SPECIAL AIRWORTHINESS INFORMATION BULLETIN

NE-05-89
September 30, 2005

DATE: August 31, 2005 Service Bulletin No. 548A
(Supersedes Service Bulletin No. 548)

SUBJECT: Diaphragm-Type Fuel Pump Inspection/Replacement

Figure 1

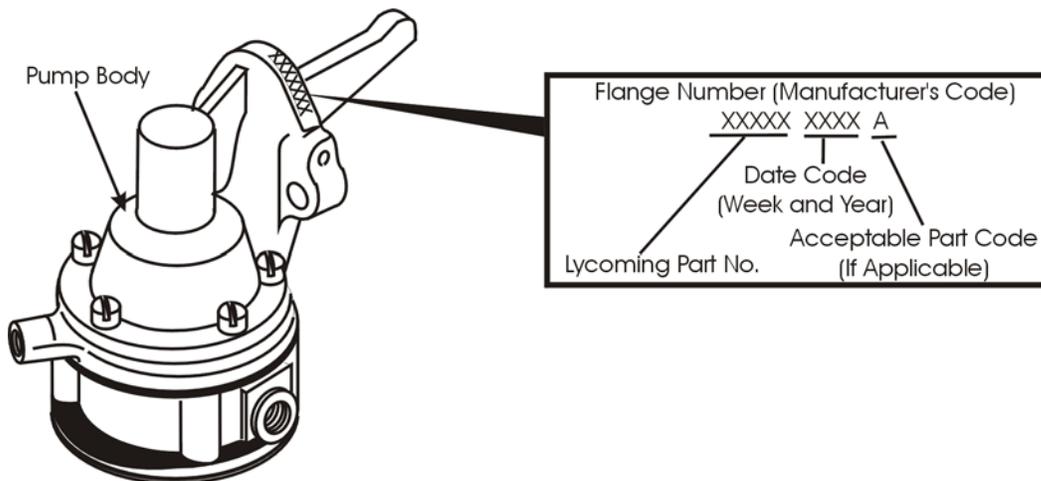
To prevent a failure of Lycoming Engine fuel pump with P/N LW-15399, LW-15472, LW-15473, or LW-16335, we highly recommend you inspect your engines for the applicable fuel pumps, as shown in Figure 1, and replace the pumps as described in Textron Lycoming Service Bulletin (SB) No. 548A. We also recommend that you check your maintenance records for affected replacement fuel pumps **received after September 15, 2005** in the event that Lycoming's September 1, 2005 fuel pump recall didn't retrieve all affected pumps. Prior compliance with Lycoming SB No. 548 requires re-inspection of the fuel pump to ensure that a fuel pump from one of the date codes added by Revision "A" was not installed when originally complying with Lycoming SB No. 548.

- Textron Lycoming engine that has a diaphragm-type fuel pump, P/N LW-15399, LW-15472, LW-15473, or LW-16335 installed, with one of the following date codes in the 6th through 9th digit locations scribed on the pump:

0101	0201	0301	0700	0800	1100	1200
1300	1400	1500	1600	1800	2000	2100
2200	2300	2400	2800	2900	3000	3100
3200	3300	3400	3500	3600	3700	3800
3900	4000	4100	4200	4300	4400	4500
4600	4700	4800	4900	5000	5100	5200
0401

Example: 163354800 needs to be replaced as specified in Textron Lycoming Service Bulletin No. 548A.

- If the letter “A” is marked as a suffix to the date code, the *pump manufacturer has repaired the pump and replacement is not necessary.*

Example: 163354800A

Figure 1

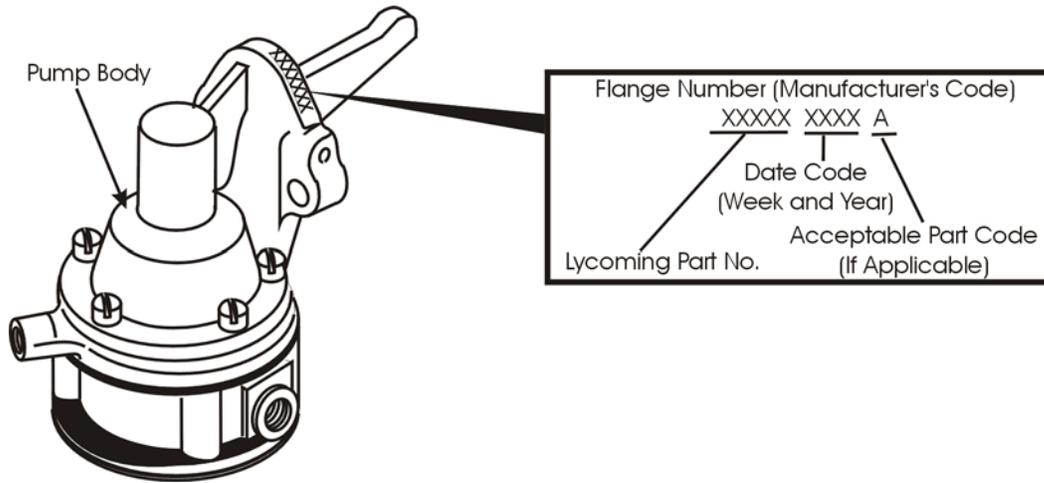
If your Lycoming engine has a diaphragm-type fuel pump with Lycoming P/N LW-15399, LW-15472, LW-15473, or LW-16335 installed, and has a date code of 0700 through 0401, the pump must be replaced within the next 100 hours of operation or 180 calendar days from the date of this Service Bulletin, whichever occurs first.

To identify affected pumps, check the manufacturer's code scribed on the flange of the pump (See Figure 1). If the first five digits are 15399, 15472, 15473, or 16335, and the 6th through 9th digits are 0700, 0800, 1100, 1200, 1300, 1400, 1500, 1600, 1800, 2000, 2100, 2200, 2300, 2400, 2800, 2900, 3000, 3100, 3200, 3300, 3400, 3500, 3600, 3700, 3800, 3900, 4000, 4100, 4200, 4300, 4400, 4500, 4600, 4700, 4800, 4900, 5000, 5100, 5200, 0101, 0201, 0301 or 0401, the pump is affected and must be replaced.

If the letter "A" is marked as a suffix to the date code, the pump has been brought into conformity and need not be replaced.
